CITY OF CHARLOTTESVILLE, VIRGINIA
CITY COUNCIL AGENDA

Agenda Date:	January 3, 2022
Action Required:	Consideration of an application for a Critical Slope Waiver
Presenter:	Brian Haluska, Principal Planner, Neighborhood Development Services
Staff Contacts:	Brian Haluska, Principal Planner, Neighborhood Development Services
Title:	P21-00082 – 1221, 1223 and 1225 Harris Street, request for a Critical Slope Waiver

CITY OF CHARLOTTESVILLE
DEPARTMENT OF NEIGHBORHOOD DEVELOPMENT SERVICES
STAFF REPORT

PLANNING COMMISSION REGULAR MEETING
APPLICATION FOR A CRITICAL SLOPE WAIVER
APPLICATION NUMBER: P21-0082
DATE OF MEETING: December 14, 2021

CRITICAL SLOPES EXHIBIT - ZONING & SUBDIVISION ORDINANCE

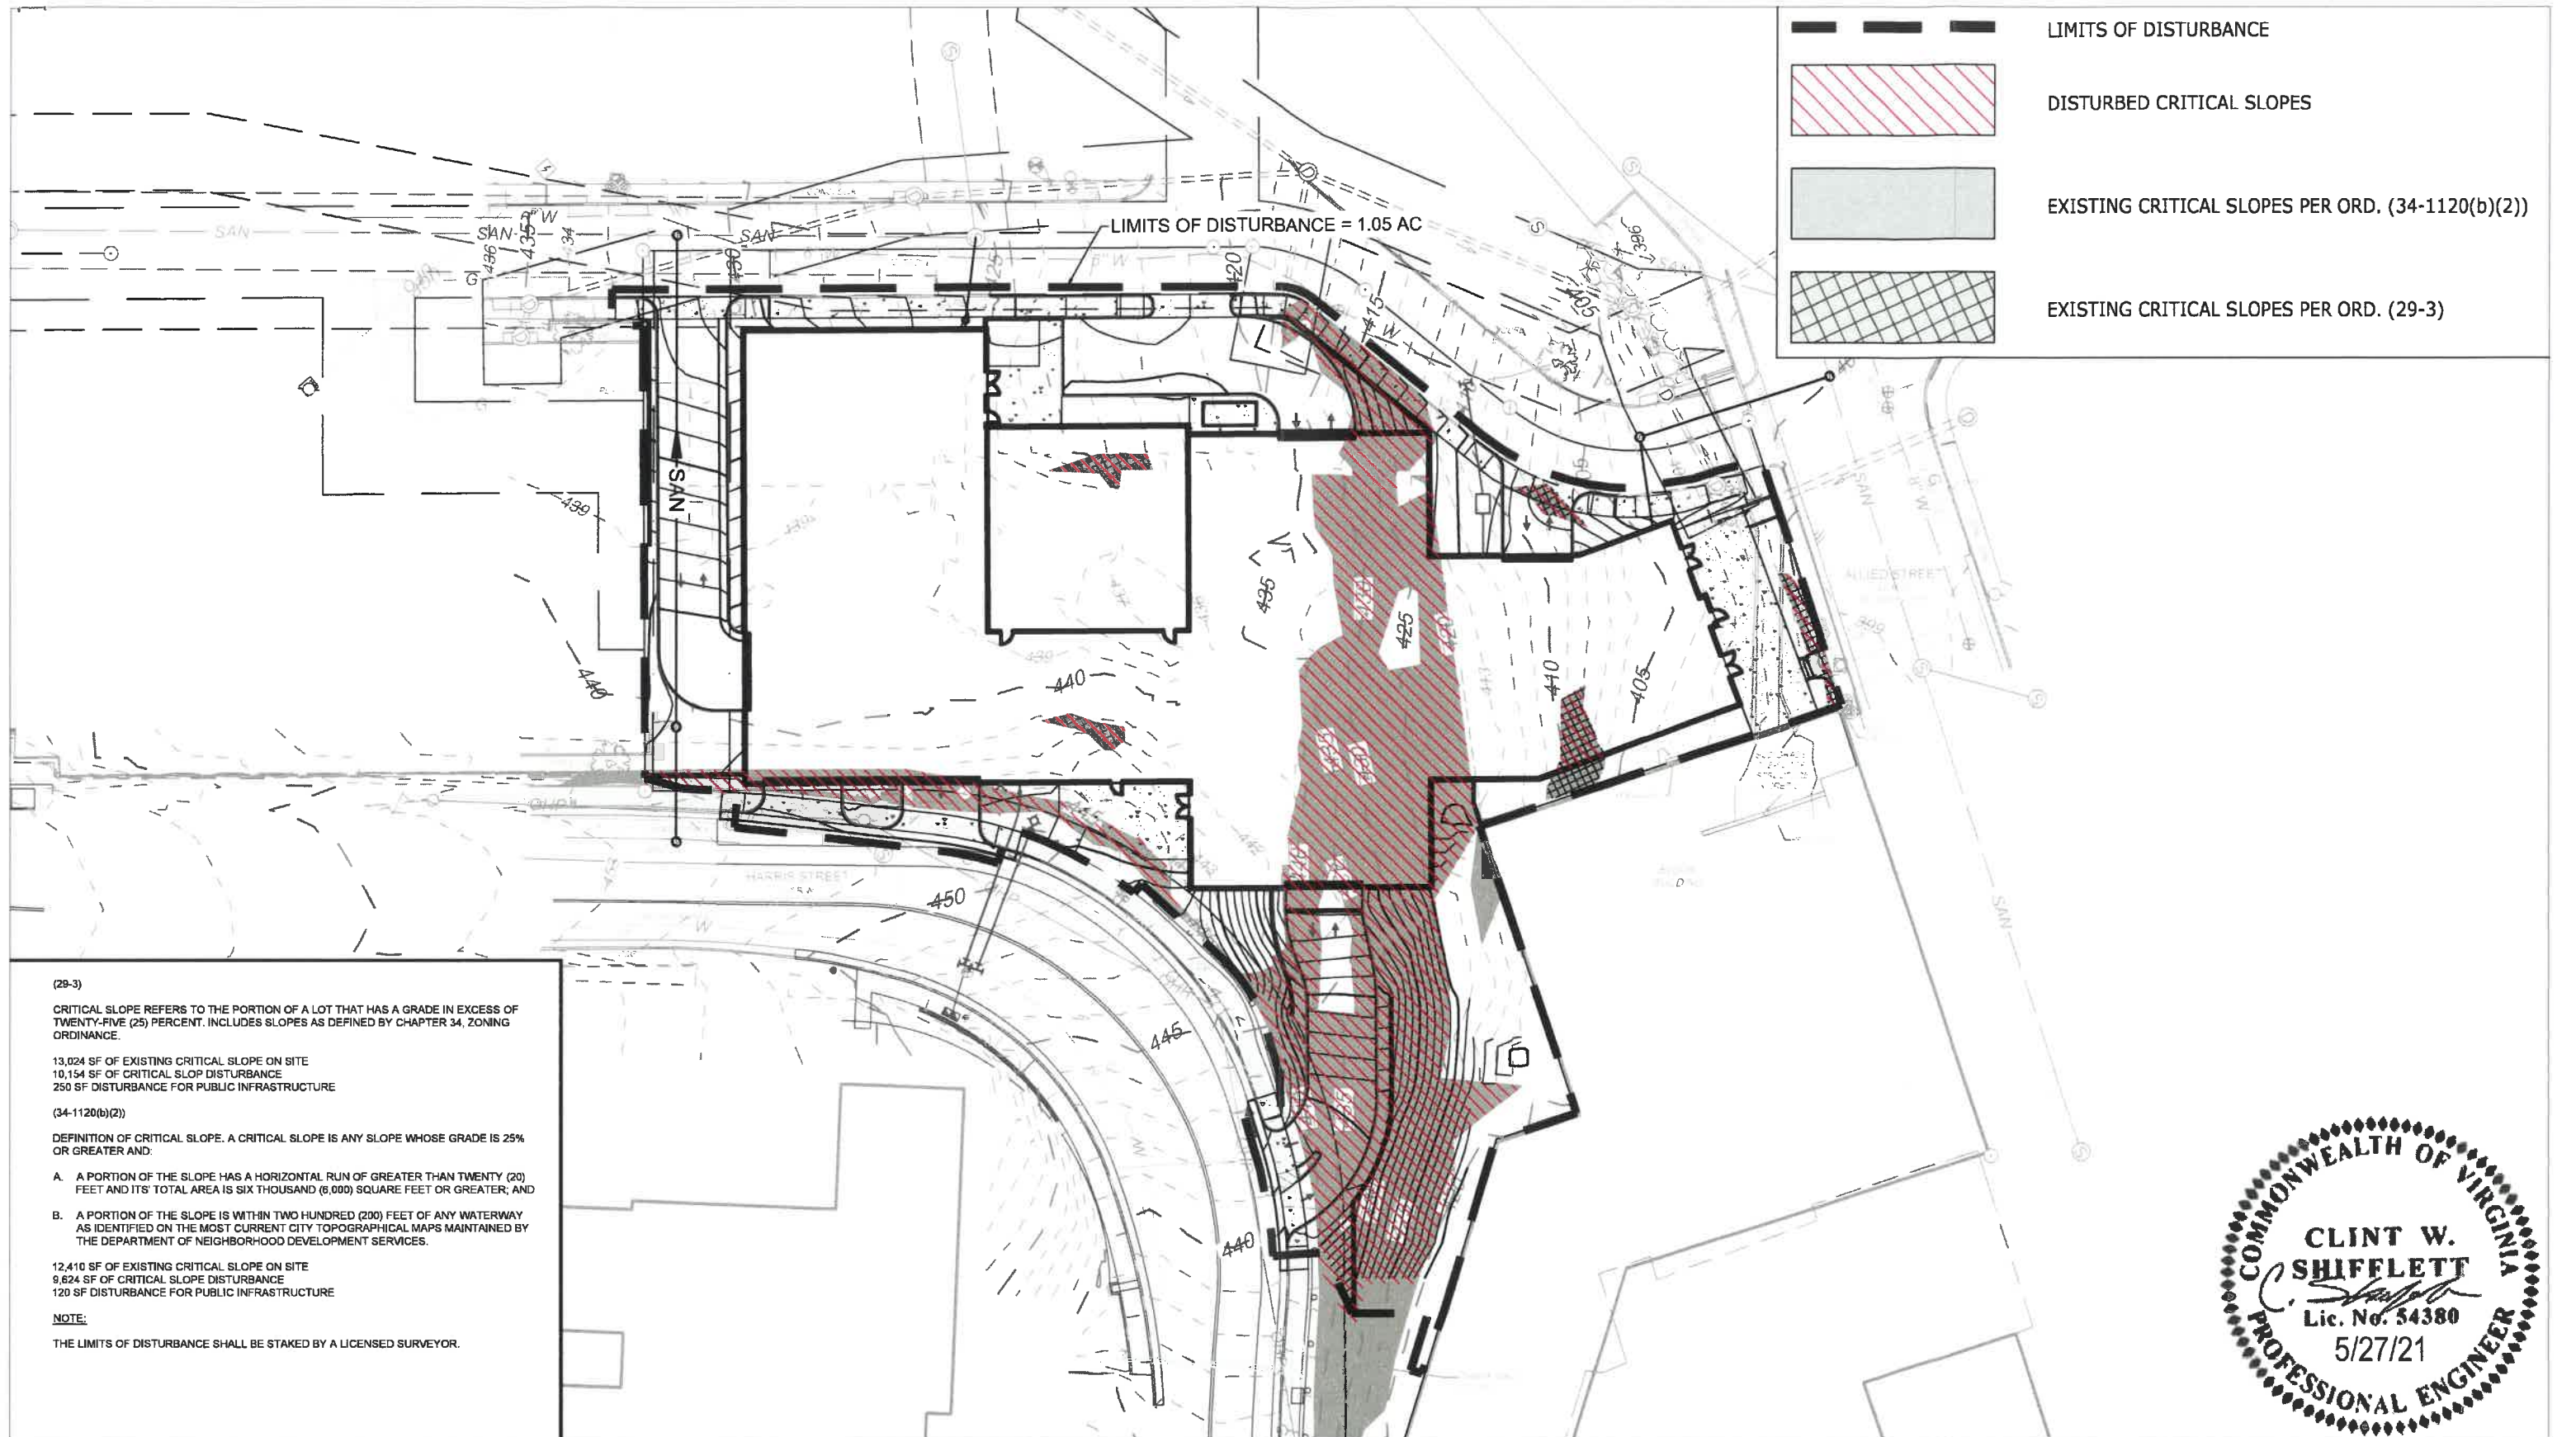
The applicant references ESC measures being implemented. These plans are under development. For such a small site, it is very complicated but the last review generated comments primarily about clarifying the sequence for constructability (clarity for contractor) as well as comments about the “SSF” being applied at the perimeter and limits of flow length to silt fence. This ESC scheme has progressed significantly and is near approvable.

c. Stormwater and erosion-related impacts to environmentally sensitive areas such as streams and wetlands. There is a “conveyance” adjacent the site. It is not considered a natural channel.

d. Increased stormwater velocity due to loss of vegetation. Discharges downstream of the site should remain at similar amounts due to VSMP compliance parameters. Since most outfalls are being “reused”, velocity will remain similar.

e. Decreased groundwater recharge due to changes in site hydrology. There is no mitigation proposed for groundwater recharge. Existing slopes and impervious limit recharge opportunities in both existing and proposed conditions.

f. Loss of natural or topographic features that contribute substantially to the natural beauty and visual quality of the community such as loss of tree canopy, forested areas and wildlife habitat. There was not mitigation addressed for loss of natural features. There are extremely limited natural features regarding canopy or habitat in existing conditions.

Based on the submitted materials and the applicant’s justifications, engineering cannot recommend approval under either Finding #1 or Finding #2. The plan is not yet approvable, though still under development. City Engineering provides the following recommended conditions which have been selected for based on the design and review history of this project. Most are already incorporated into the design. If the Planning Commission decides to approve the project, the following should be considered for applicable conditions:

- 1) Site Plans (VESCP Plans) should include, at a minimum, 4 stages/phases of ESC controls. The first phase shall include “Initial/Preliminary Controls”. Outfalls from any proposed traps shall be established with rigorous independent ESC controls, early in the sequence, prior to the establishment of a sediment trap and associated conveyances.
- 2) “Super Silt Fence” (chain linked backing) shall be installed where perimeter silt fence is specified.
- 3) At no time shall concentrated water be directed toward the critical slopes.
